Work Order ID 73224

DESIGN <i>PH</i>	DRAWN BY <i>PH</i>	DART AEROSPACE LTD HAWKESBURY, ONTARIO, CANADA	
CHECKED <i>PH</i>	APPROVED <i>PH</i>	DRAWING NO. D3303	REV. B SHEET 1 OF 4
DATE 06.08.17		TITLE HEAD REST	SCALE 1:3
REV	DATE	DESCRIPTION	
A	04.08.18	NEW ISSUE	
B	06.08.17	UPDATED FLAT PATTERN TO FORM PART IN ONE OPERATION USING OFFSET DIE

D3303-041 HEAD REST

DRAWING NO. D3303	TITLE HEAD REST	REV. B	DART AEROSPACE LTD ENGINEERING ORDER		D.E.O. NO. D3303-B-1	SHEET NO. SHEET 1 OF 1	SCALE NTS
DRAWN AJS	CHECKED <i>[Signature]</i>	MFG. APPR. <i>[Signature]</i>	APPROVED <i>[Signature]</i>		DE APPR. <i>[Signature]</i>		
DATE 08.10.15	DATE 08.10.15	DATE 08/10/16	DATE 08/10/16		DATE 08/10/16

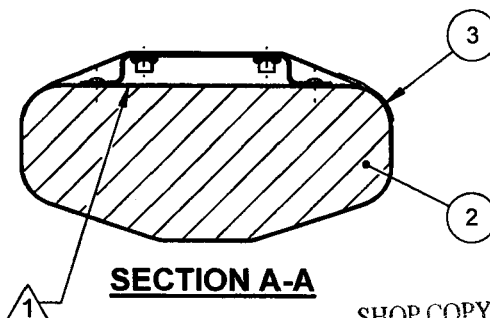
SHEET 1 ADD 1300L ADHESIVE BY 3M TO NOTE 1 AS FOLLOWS:

IS:

- 1) BOND D3305-1 FOAM TO D3303-043 BRACKET ASSEMBLY USING 3M 1300 OR 1300L ADHESIVE (0.002" TO 0.010" THICK) IN ACCORDANCE WITH MANUFACTURER'S INSTRUCTIONS
